OFFICE AUTHORITY FILE COPY
UNITED STATES
NUCLEAR REGULATORY COMMISSION
WASHINGTON, D. C. 20555

BROWNS FERRY NUCLEAR PLANT, UNIT 2

AMENDMENT TO FACILITY OPERATING LICENSE

Amendment No. 85
License No. DPR-52

Figure 3.5.K-1
MCPR Limits

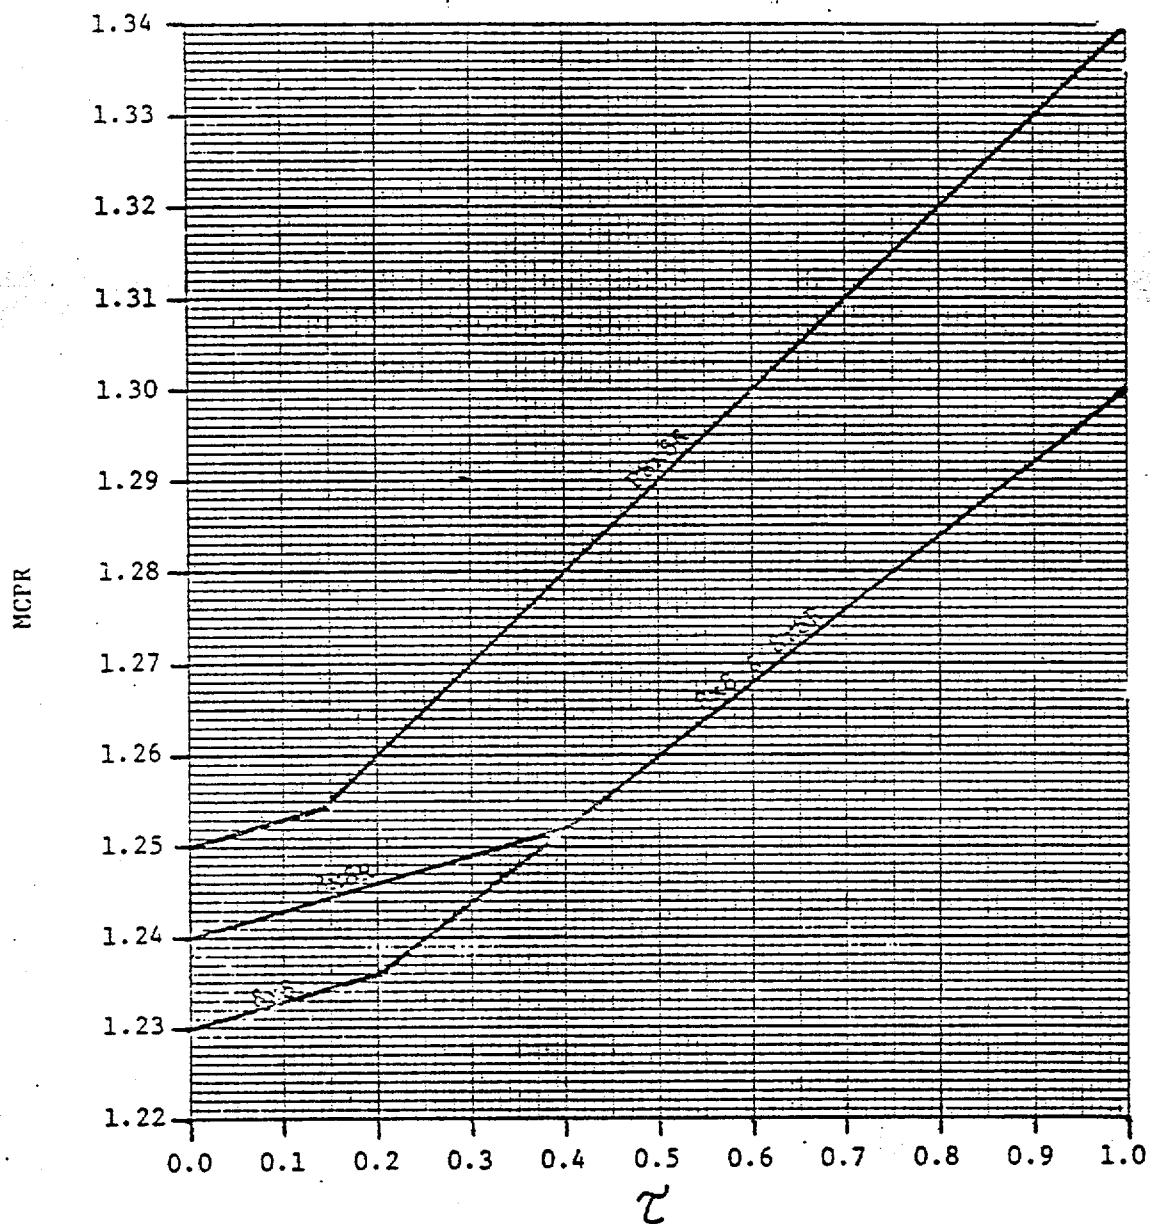
This is the first reload for BF-2 for which the overpressurization transients were analyzed with the ODYN code. Specification 3.5.k and Surveillance Requirement 4.5.k have been revised to reflect the new analyses. This procedure, which was previously reviewed and found acceptable by the staff, is being introduced on all operating BWRs and therefore, is acceptable for BF-2.

The minimum critical power ratio (MCPR) as a function of scram time and core flow, shall be equal to or greater than shown in Figure 3.5.K-1 multiplied by the K_f shown in Figure 3.5.2, where:

2. The MCPR limit shall be determined for each fuel type 8X8, 8X8R, P8X8R, from Figure 3.5.K-1 respectively using:
